HISTORIC LANDMARK COMMISSION
APPLICATION FOR A CERTIFICATE OF APPROPRIATENESS
MAY 3, 2023
HR-2023-020343
HOEFGEN-WILSON-RANSOM HOUSE
1610 WATCHHILL ROAD

Remodel a ca. 1962-64 rear carport into a two-story home office.

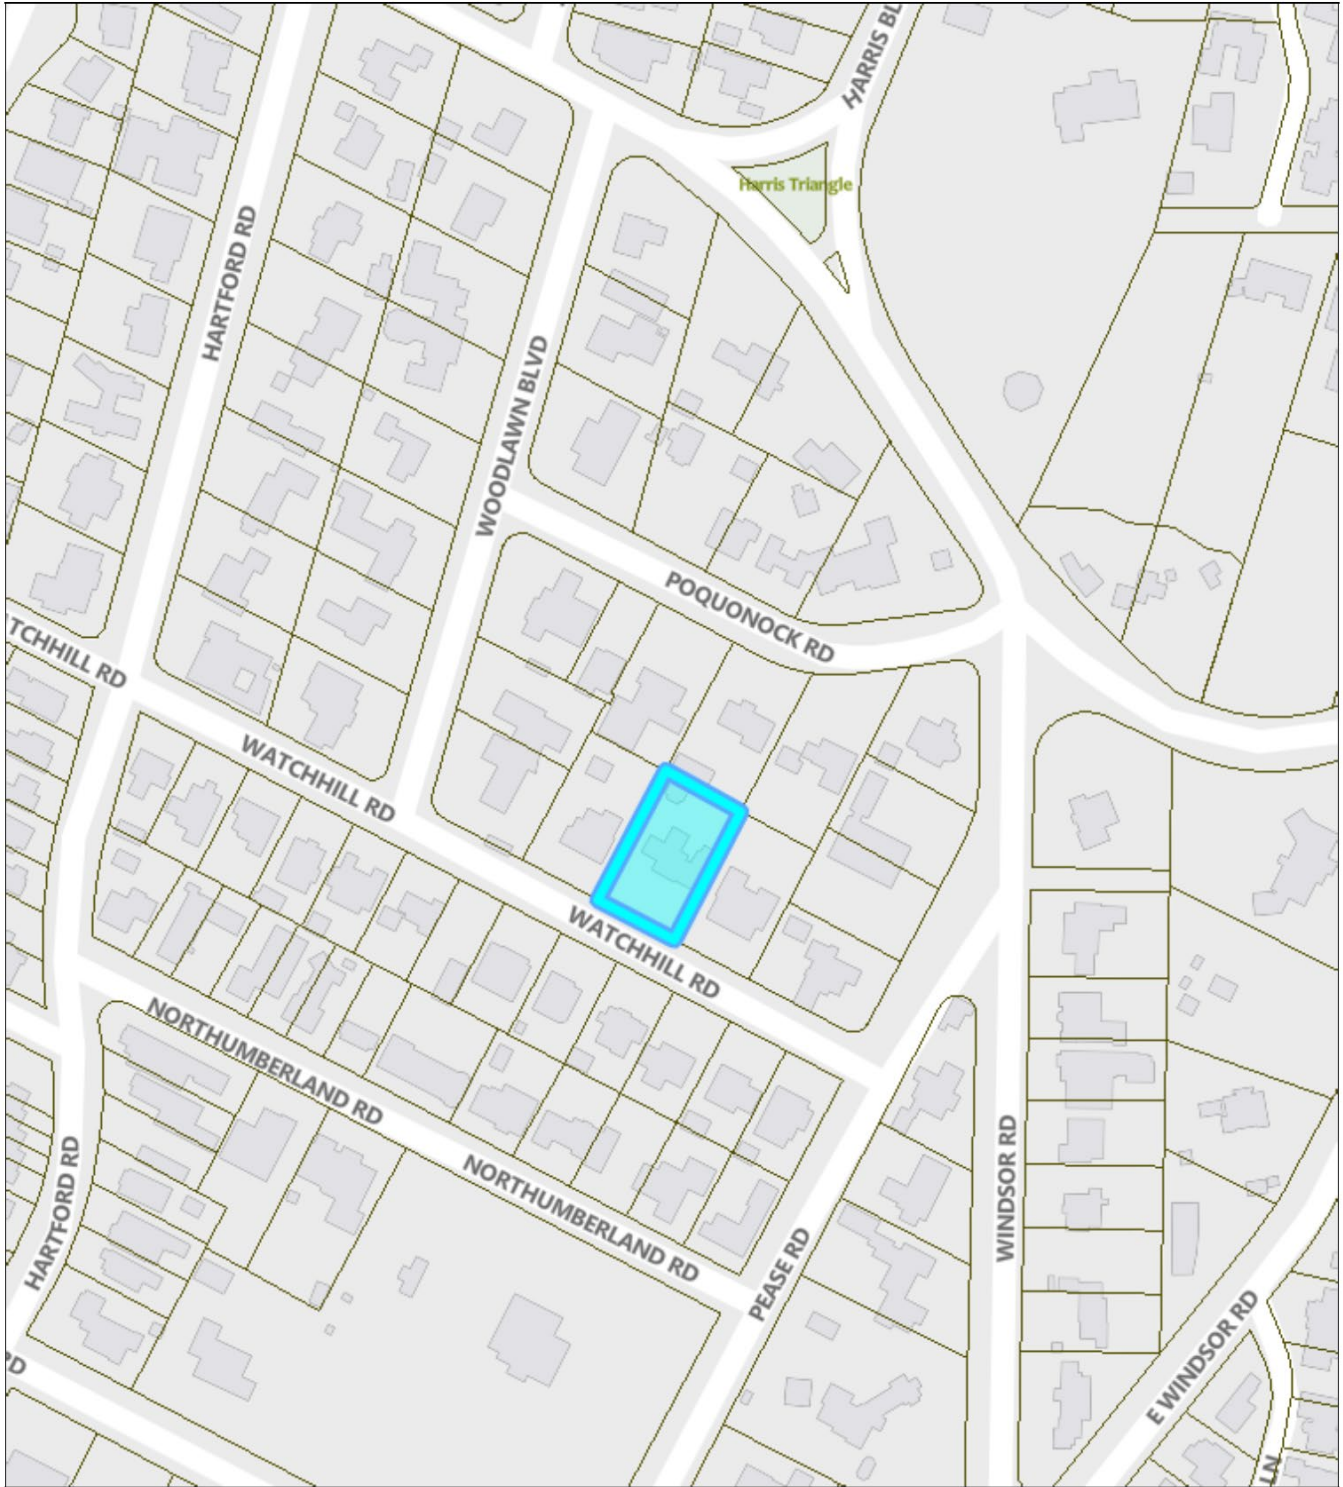
Select a flat-roofed design rather than a pitched-roof design.

Approve the application. The applicant has amended the design to address committee feedback.
